CITY OF West Linn

STAFF REPORT FOR THE PLANNING COMMISSION

FILE NUMBER: DR-23-01

REQUEST: The applicant is requesting approval for the demolition of two existing structures, to be replaced with a two-story commercial building with underground parking and a rooftop deck at 1919 and 1949 Willamette Falls Drive.

2 SECOND FLOOR PLAN + EAST & 12th STREET ELEVATIONS

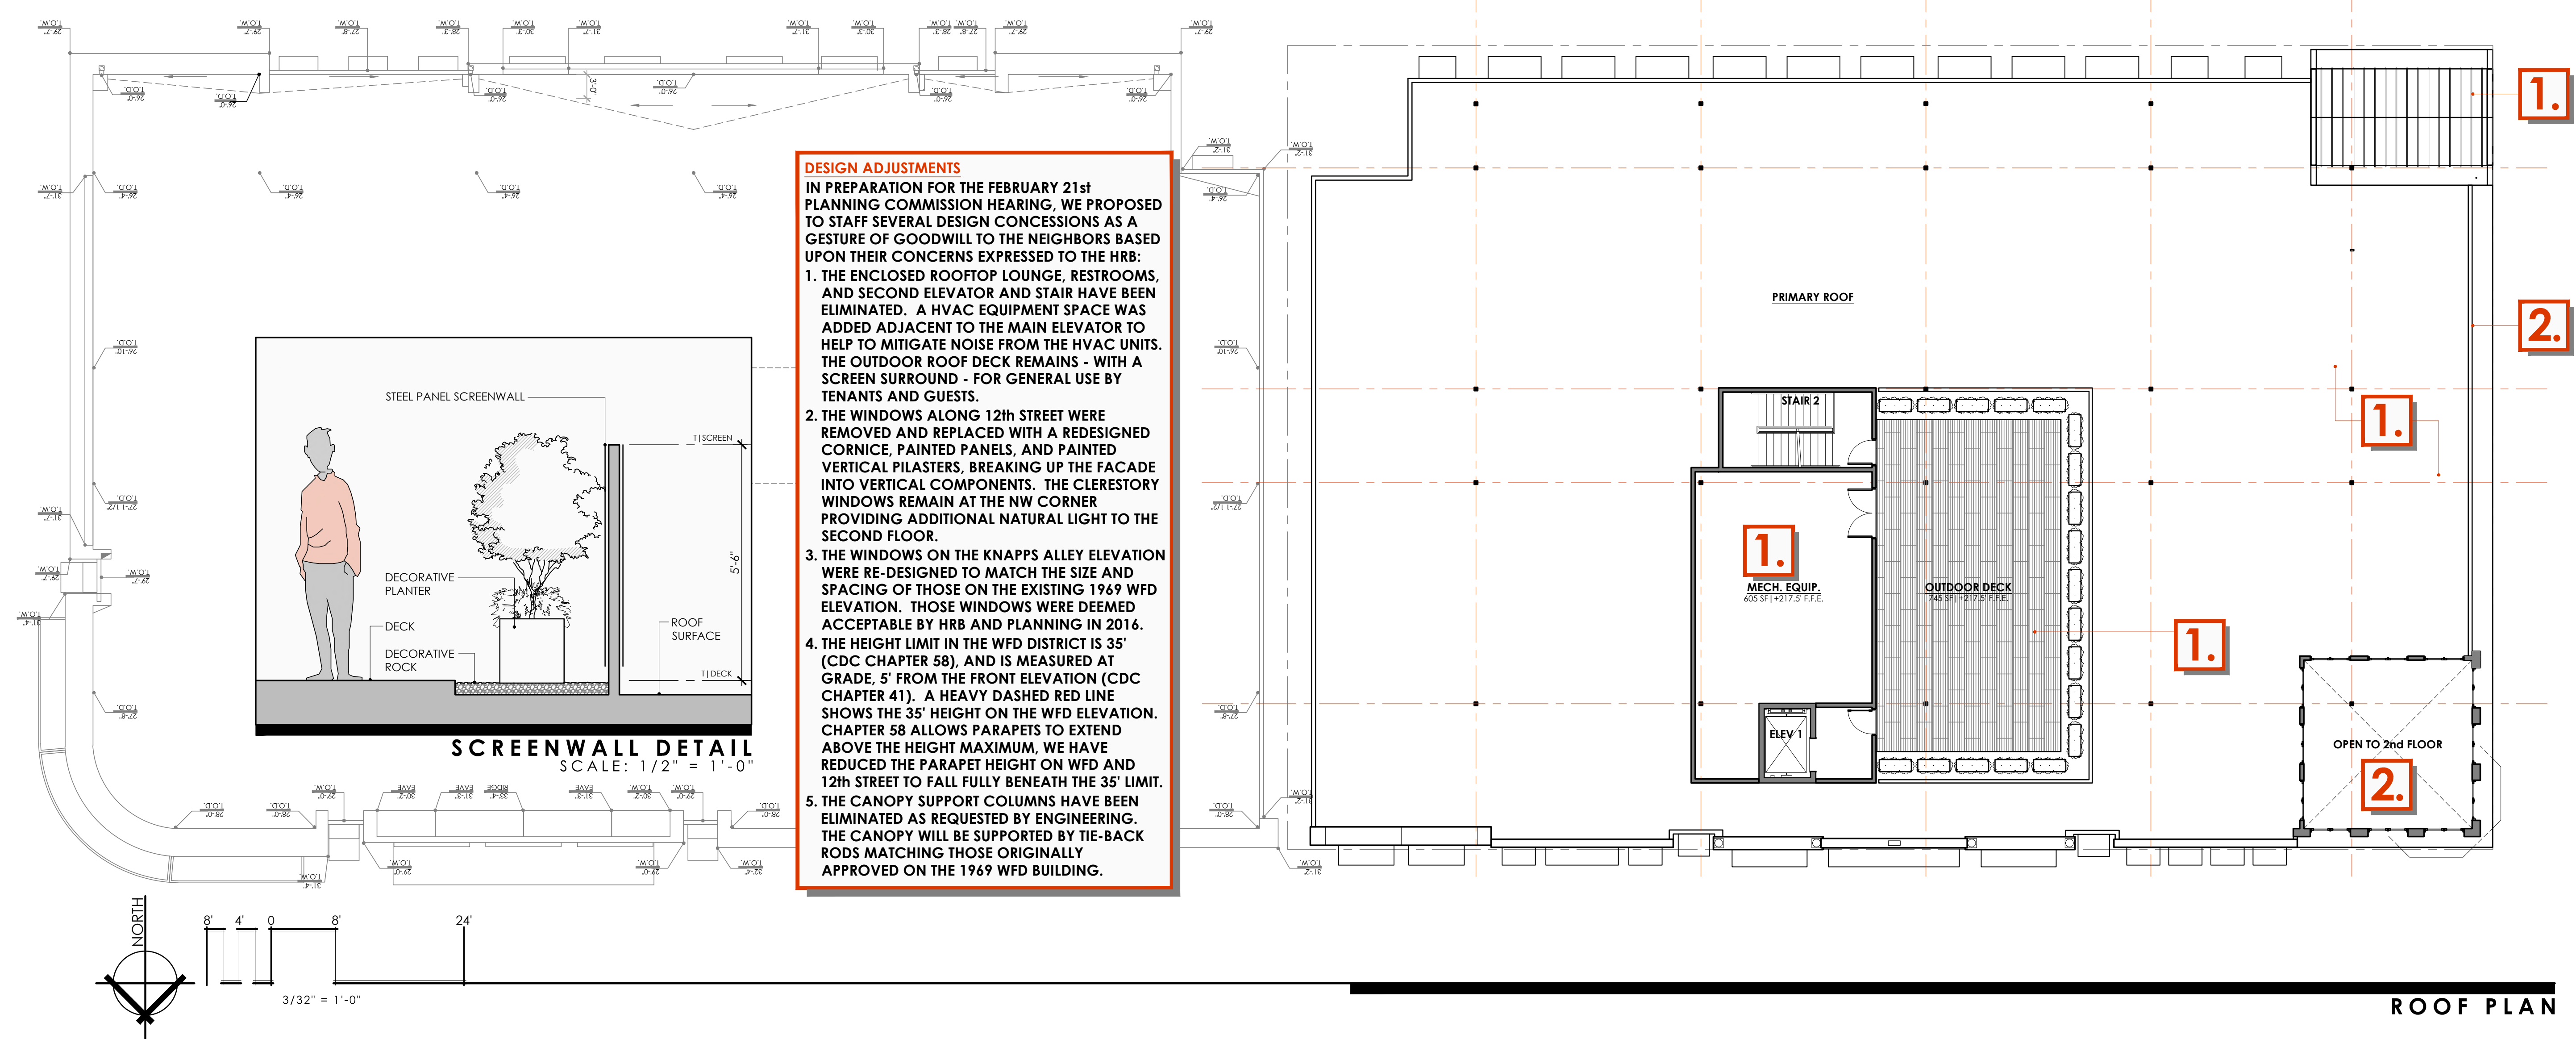
6. **Vertical Breaks.** Prior to issuance of building permits, the applicant shall submit building permit plans with revised western and southern elevations that demonstrate compliance with CDC 58.080.C.7 that requires strong vertical breaks or lines regularly spaced every 25 to 50 feet.

1. THE ENCLOSED ROOFTOP LOUNGE, RESTROOMS, AND SECOND ELEVATOR AND STAIR HAVE BEEN ELIMINATED. A HVAC EQUIPMENT SPACE WAS ADDED ADJACENT TO THE MAIN ELEVATOR TO HELP TO MITIGATE NOISE FROM THE HVAC UNITS. THE OUTDOOR ROOF DECK REMAINS - WITH A SCREEN SURROUND - FOR GENERAL USE BY TENANTS AND GUESTS.

2. THE WINDOWS ALONG 12th STREET WERE REMOVED AND REPLACED WITH A REDESIGNED CORNICE, PAINTED PANELS, AND PAINTED VERTICAL PILASTERS, BREAKING UP THE FACADE INTO VERTICAL COMPONENTS. THE CLERESTORY WINDOWS REMAIN AT THE NW CORNER PROVIDING ADDITIONAL NATURAL LIGHT TO THE SECOND FLOOR.

5. THE CANOPY SUPPORT COLUMNS HAVE BEEN ELIMINATED AS REQUESTED BY ENGINEERING. THE CANOPY WILL BE SUPPORTED BY TIE-BACK RODS MATCHING THOSE ORIGINALLY APPROVED ON THE 1969 WFD BUILDING.

1 GROUND FLOOR PLAN + WILLAMETTE FALLS DRIVE ELEVATION

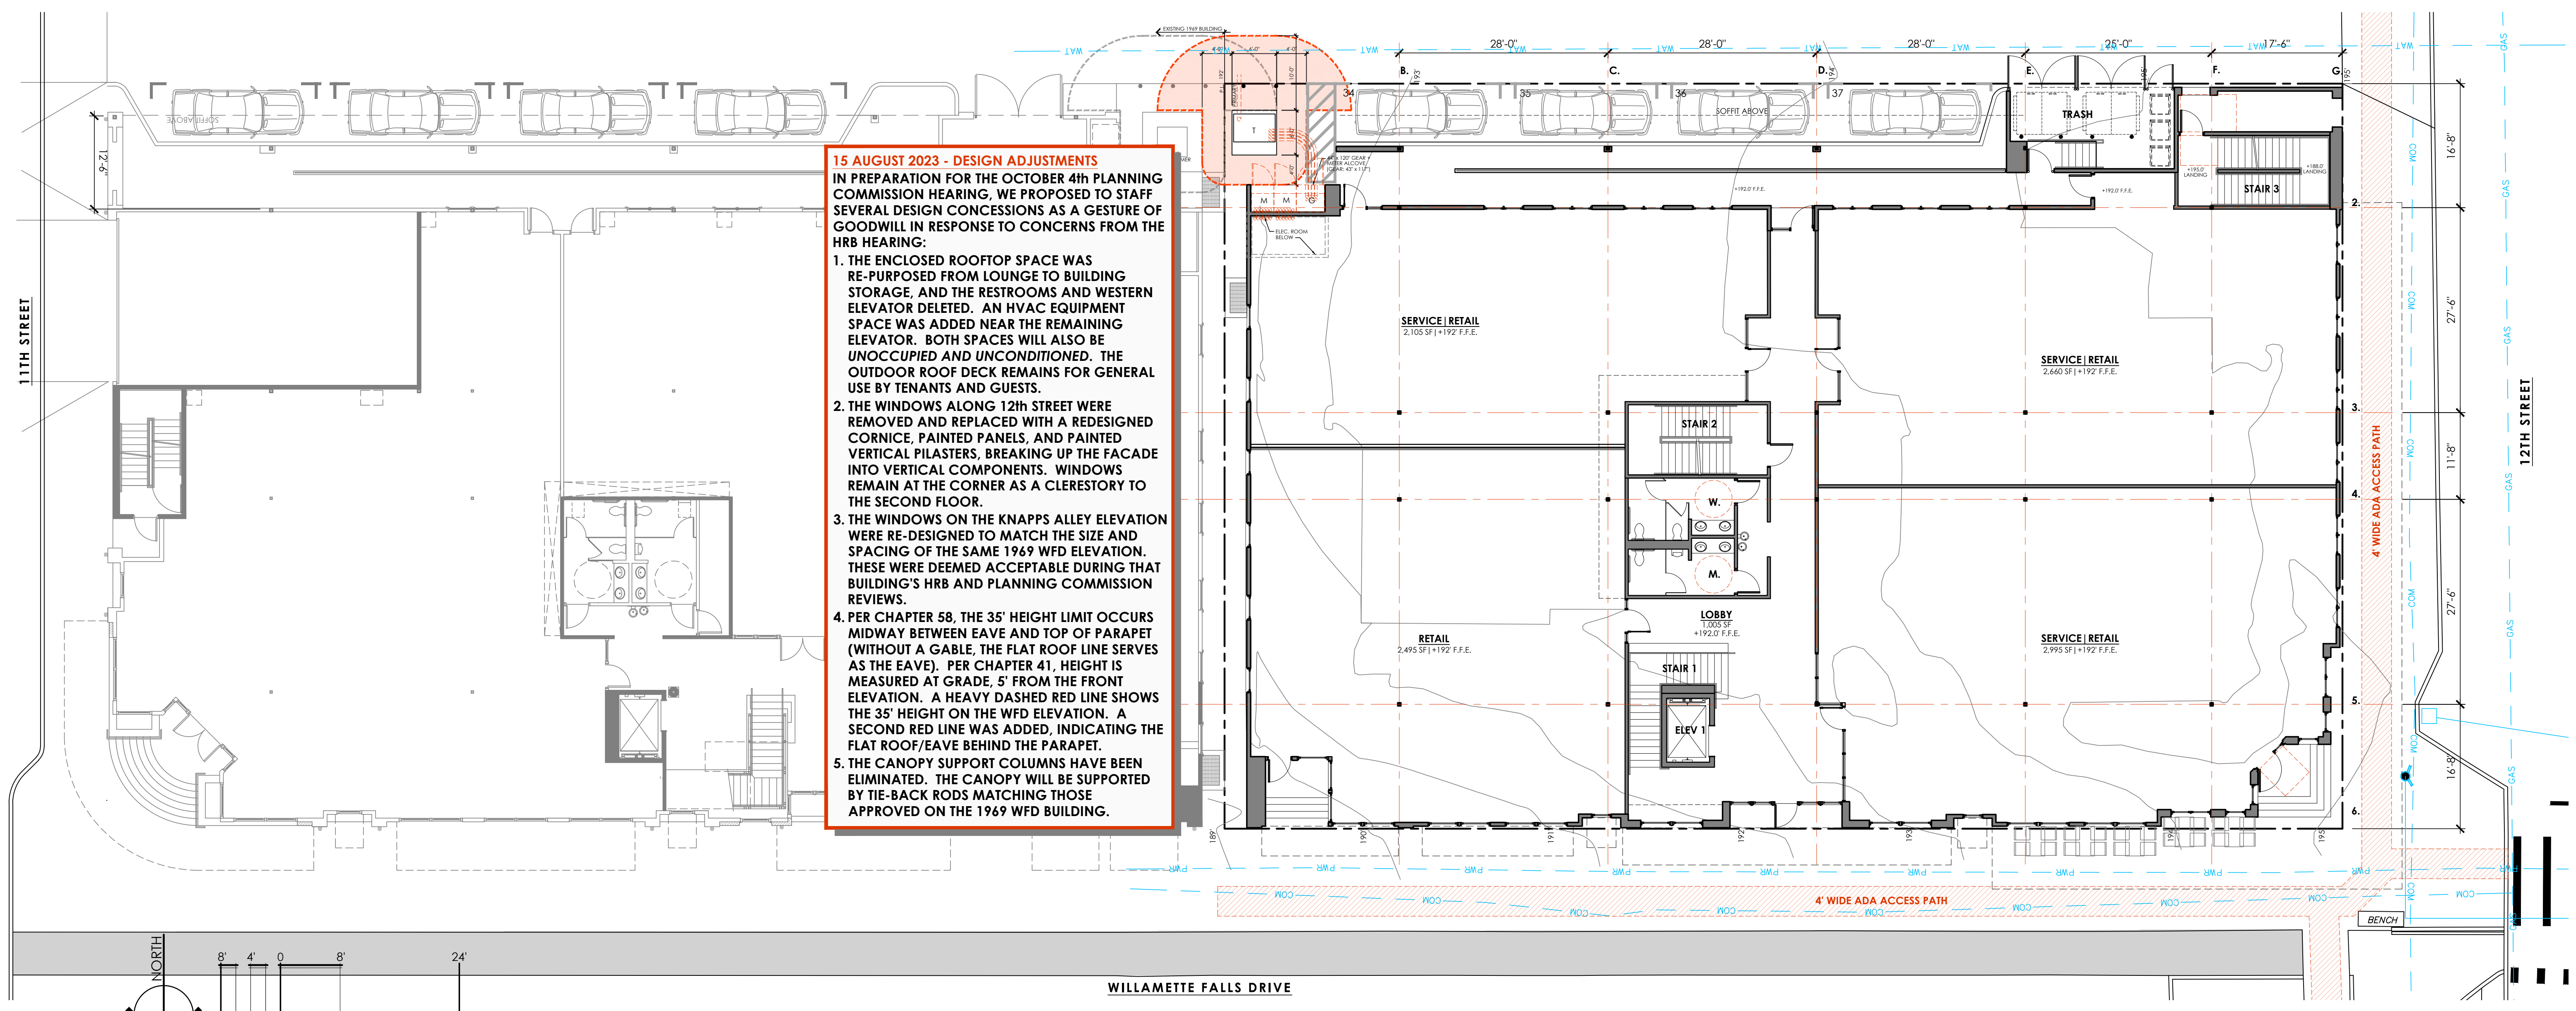
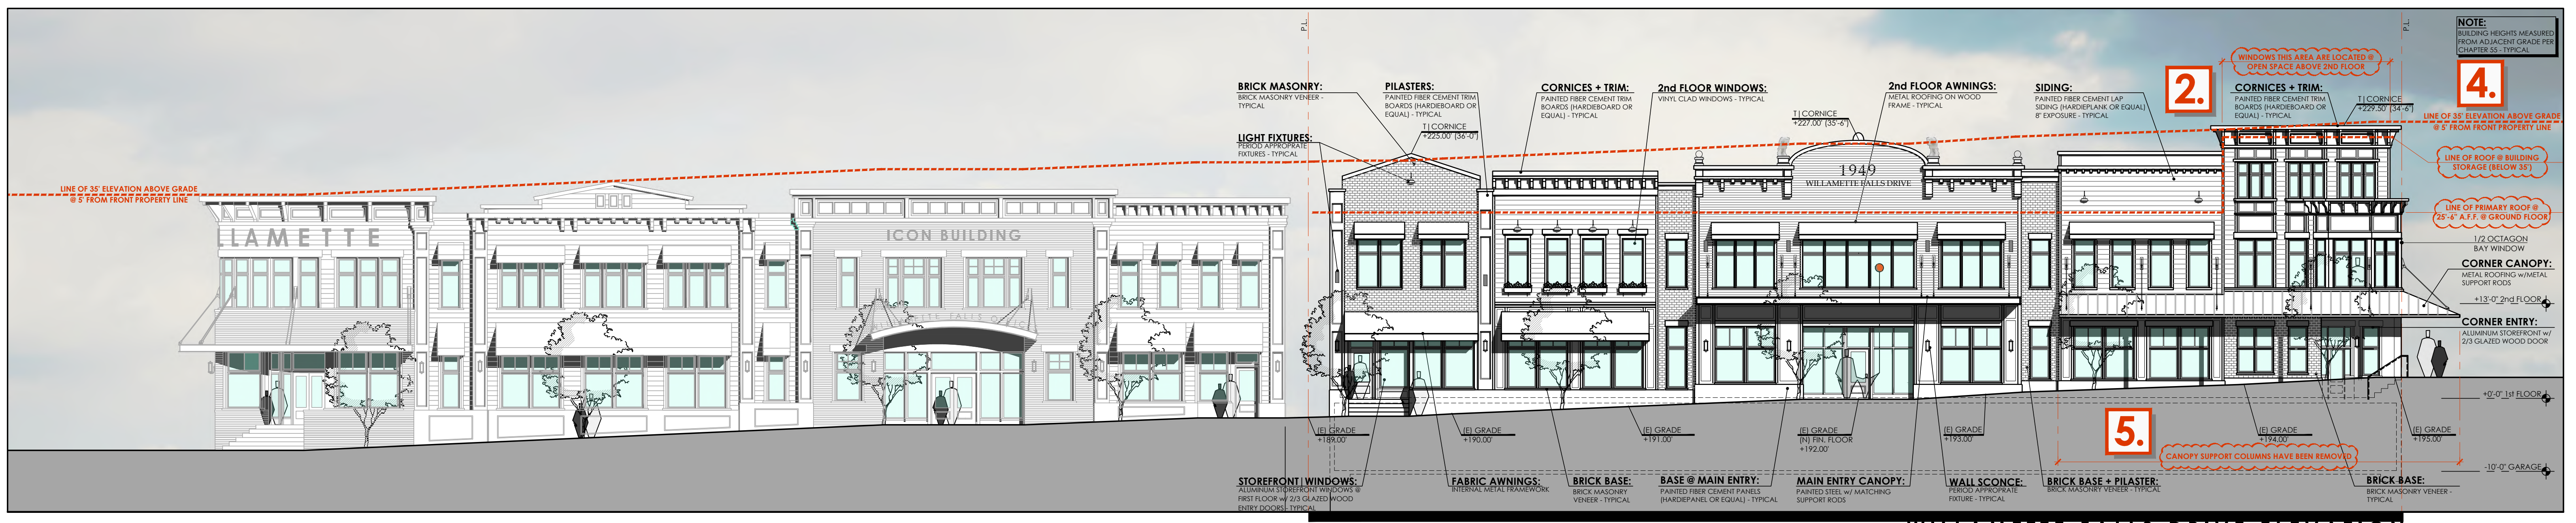
1. The Board deferred the question of the mezzanine for review by the Planning Commission for their decision.
(SEE EXHIBIT EL05/3, dated 12-2022)
2. There was concern that the uppermost windows along 12th Street suggested a third story that might be out of the norm for the WFD Design District.
(SEE EXHIBIT EL05/2, dated 07-13-2022)

1. THE ENCLOSED ROOFTOP SPACE WAS RE-PURPOSED FROM LOUNGE TO BUILDING STORAGE, AND THE RESTROOMS AND WESTERN ELEVATOR DELETED. AN HVAC EQUIPMENT SPACE WAS ADDED NEAR THE REMAINING ELEVATOR. BOTH SPACES WILL ALSO BE UNOCCUPIED AND UNCONDITIONED. THE OUTDOOR ROOF DECK REMAINS FOR GENERAL USE BY TENANTS AND GUESTS.

2. THE WINDOWS ALONG 12th STREET WERE REMOVED AND REPLACED WITH A REDESIGNED CORNICE, PAINTED PANELS, AND PAINTED VERTICAL PILASTERS, BREAKING UP THE FACADE INTO VERTICAL COMPONENTS. WINDOWS REMAIN AT THE CORNER AS A CLERESTORY TO THE SECOND FLOOR.

5. THE CANOPY SUPPORT COLUMNS HAVE BEEN ELIMINATED. THE CANOPY WILL BE SUPPORTED BY TIE-BACK RODS MATCHING THOSE APPROVED ON THE 1969 WFD BUILDING.
